INCOMPLETE APPLICATION MEMORANDUM

RE: Application Completeness Review
New Proposed Wireless Facility: Public Right-of-Way
at approximately 1544 Kenneth Road (Adjacent to APN #
5622-027-018)

RADIO FREQUENCY PLANNING MEMORANDUM

TO: Mr. Soroush Sheikhlari and Mr. Benjamin Gonzalez
FROM: Dr. Jonathan Kramer
DATE: April 26, 2023
RE: (Glendale 237)(EP 823) Radio Frequency Review for
Proposed New Wireless Site-Mounted on Replacement
Pole near 1544 West Kenneth Road.

Figure 1: Overview of Pole location (Source: Plans, page A-2, panel 1).

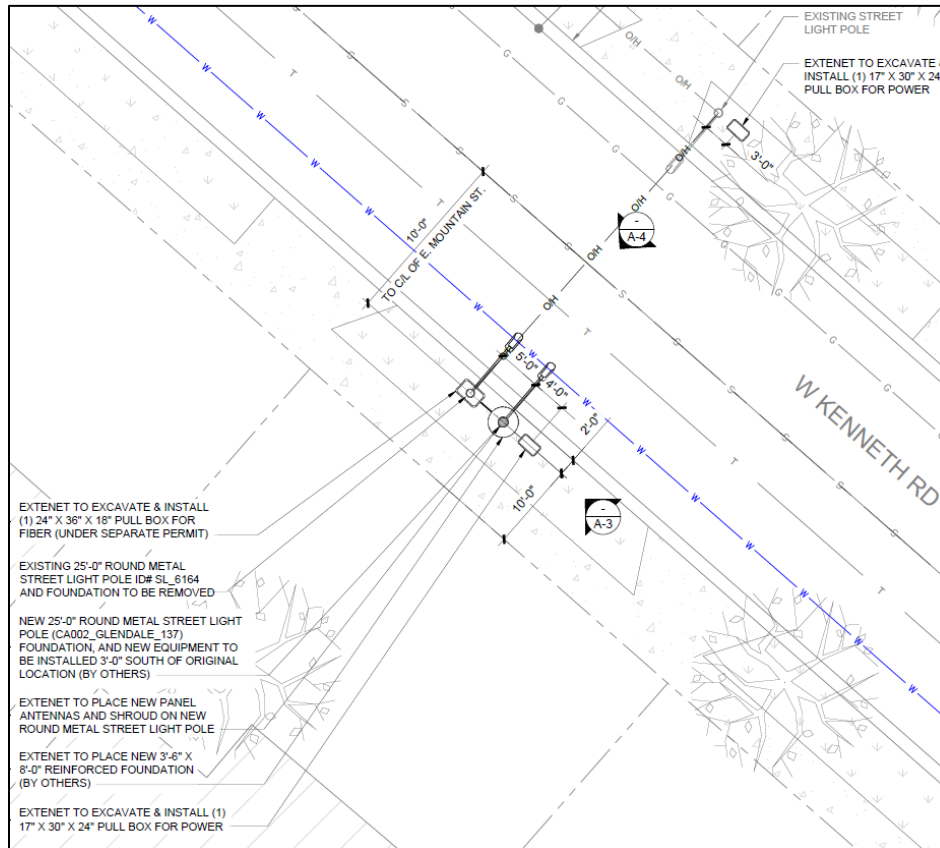
TLF notes the existing overhead power on the original structure needs to be undergrounded.

Figure 4: Proposed antenna orientations (Source: Plans, Page D-1, panel 1).

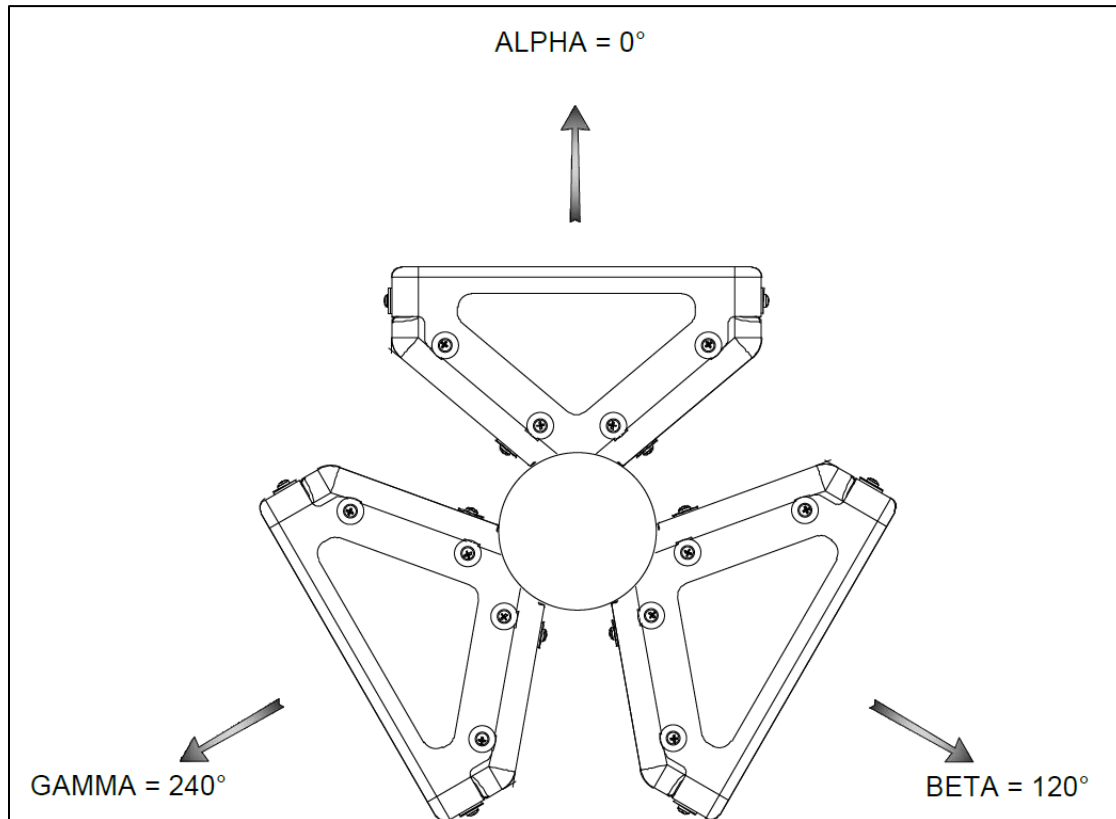
The antennas will orient in a 360° direction with Sector Alpha oriented toward 0° True North ("TN"), Sector B oriented toward 120° TN and Sector Gamma oriented toward 240° TN, see Figure 4.

Figure 5: Proposed elevation view from the north (Source: Plans, Page A-3, panel 2).

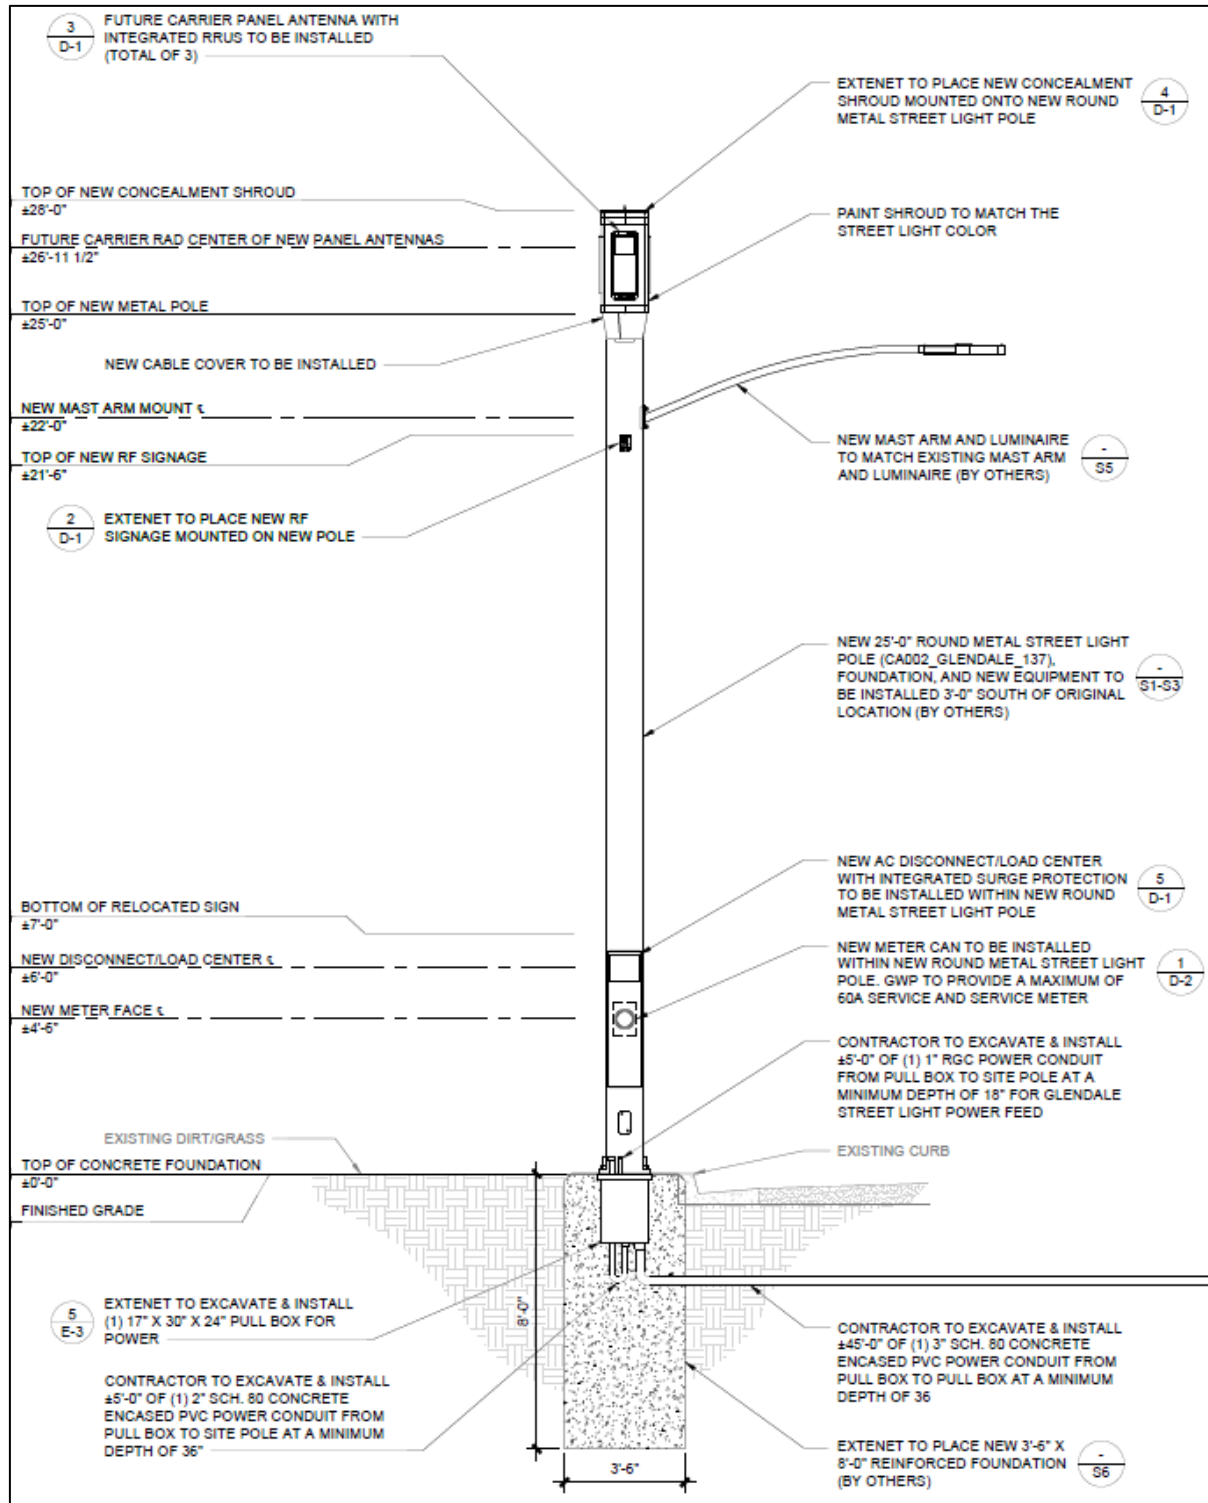
The proposed antennas are to be mounted with the centerline height of approximately 27' AGL. Verizon's proposal is depicted in elevation with details in Figure 5.

Based on the antenna power emissions, Verizon’s antennas will create a “controlled access zone” for all three sectors that extends approximately 6 feet horizontally from the face of the antennas at approximately the height of 27' AGL.
